new floor plan: level 1

project: schaumburg township district library  
130 s roselle rd  
schaumburg, il 60193

A1.0  
ASI-004  
sheet \_\_\_ of \_\_\_

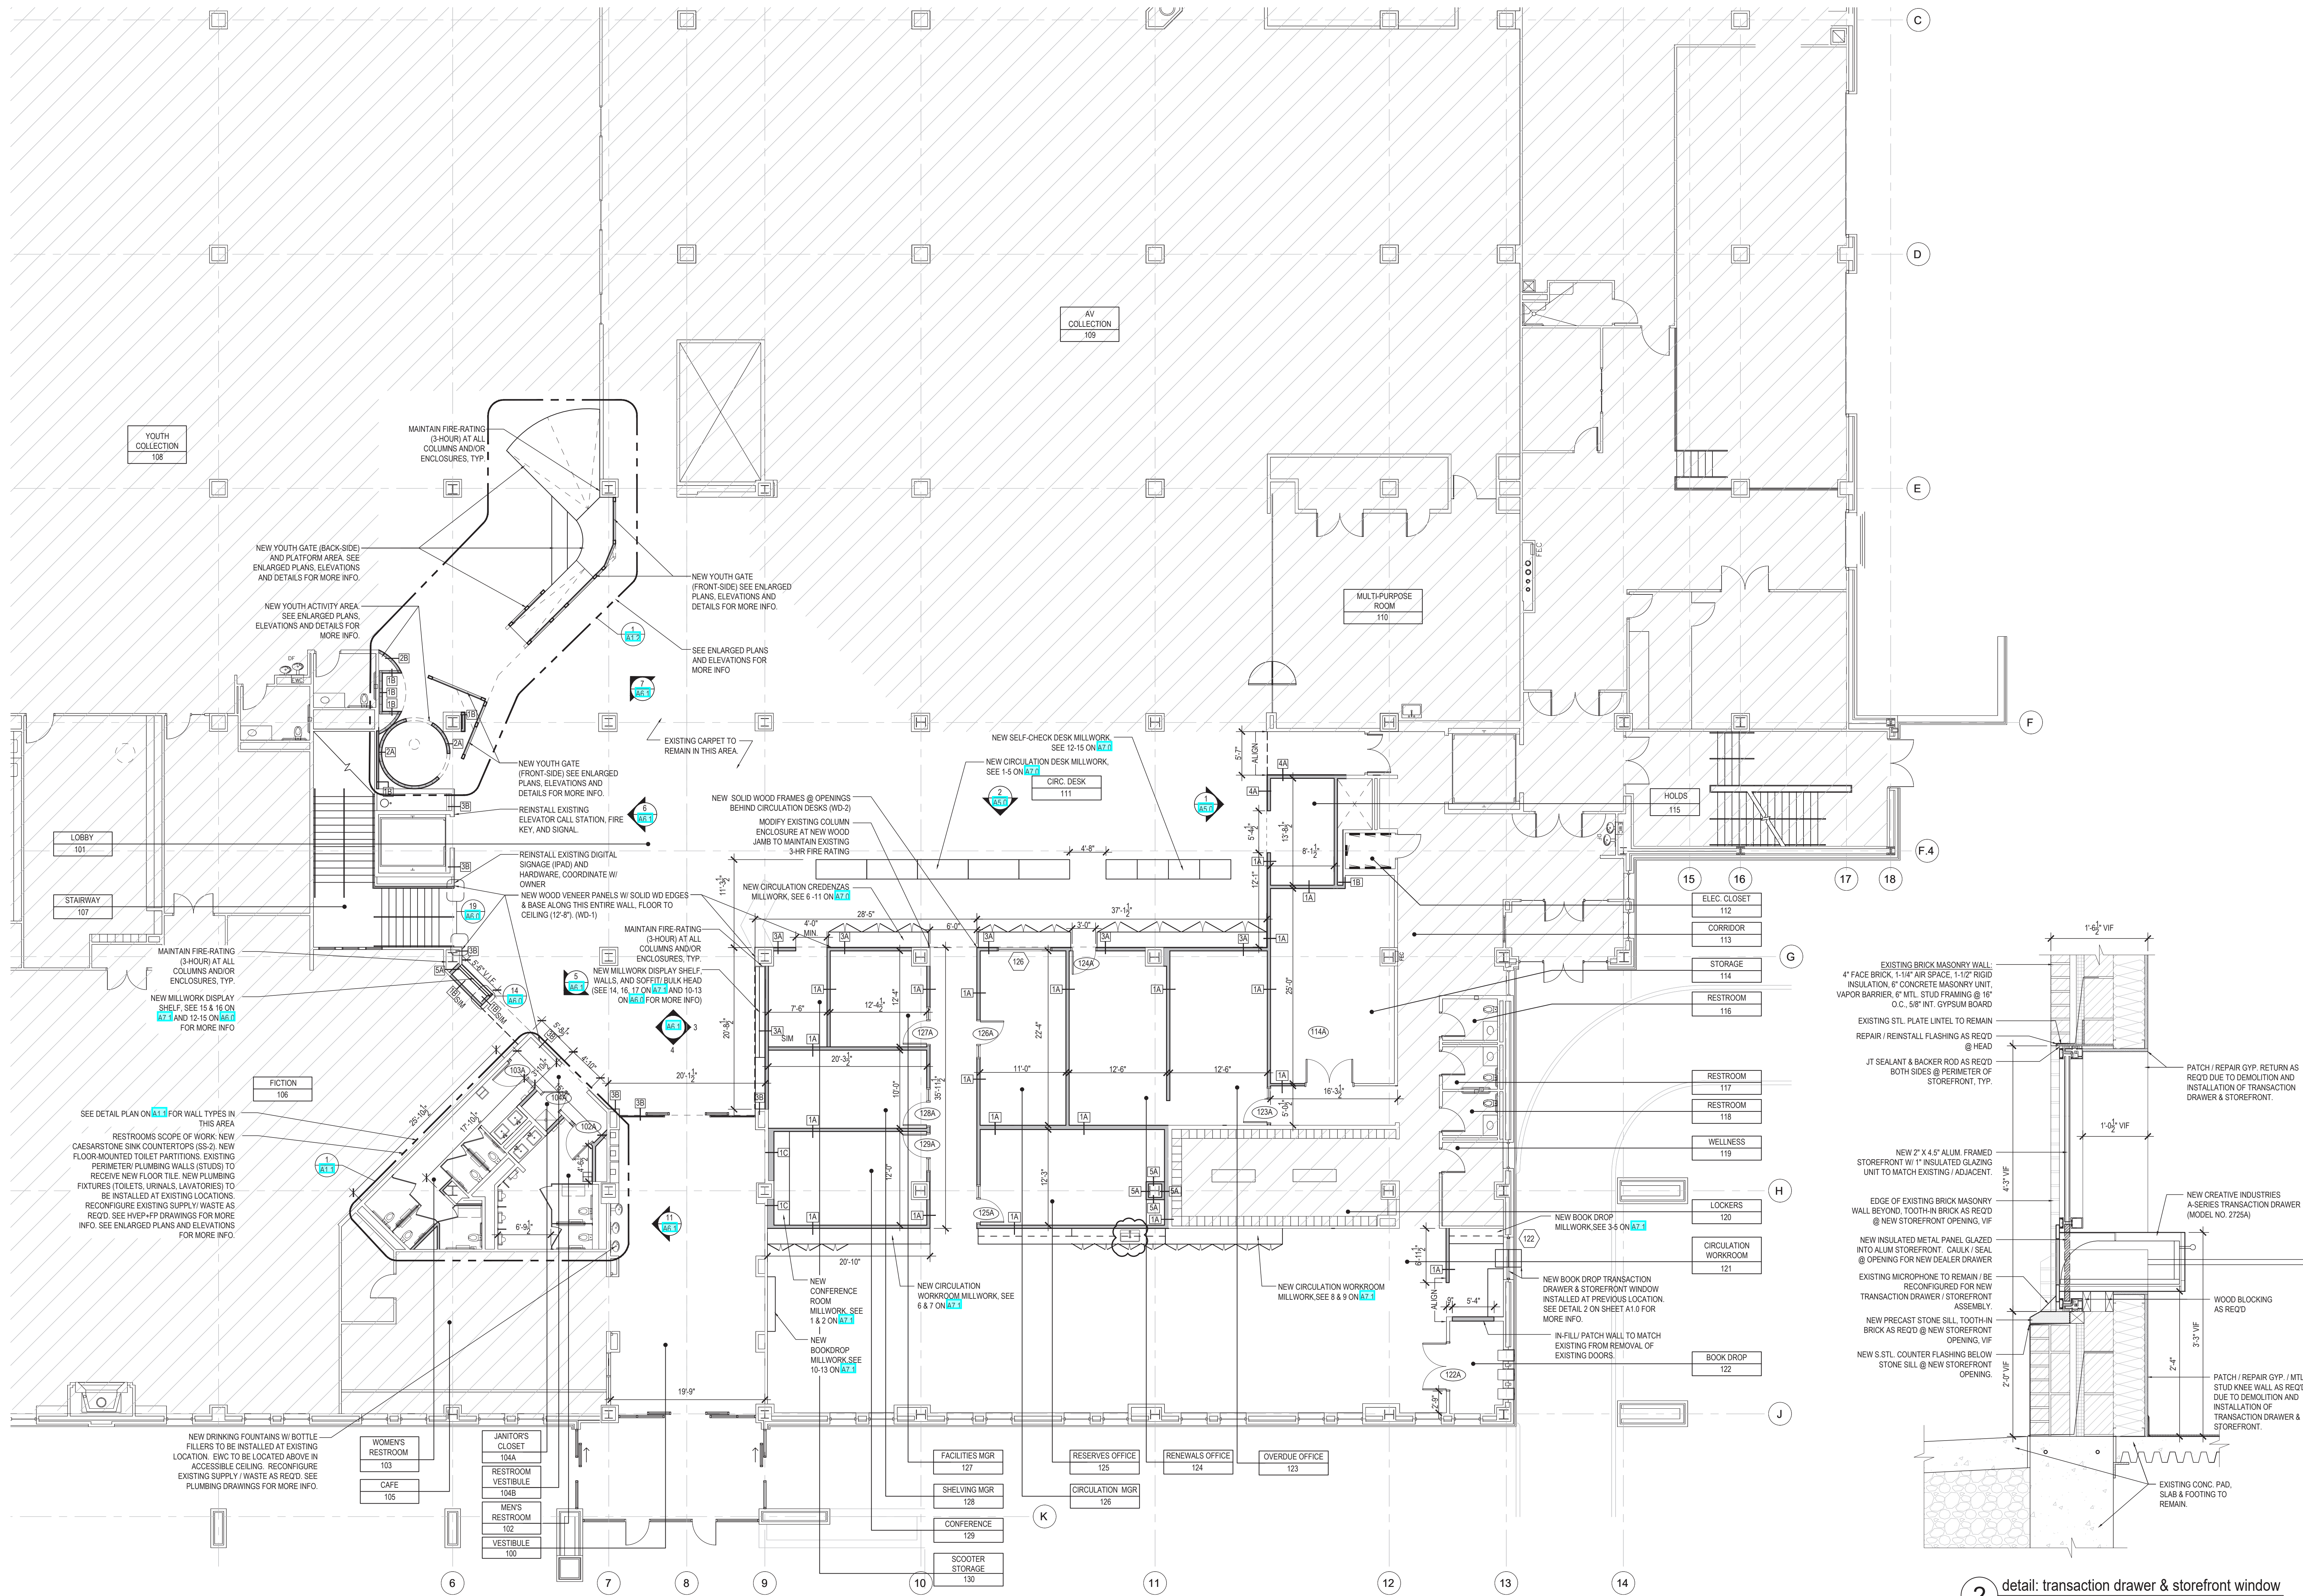
2 detail: transaction drawer & storefront window  
SCALE: 1" = 1'-0"
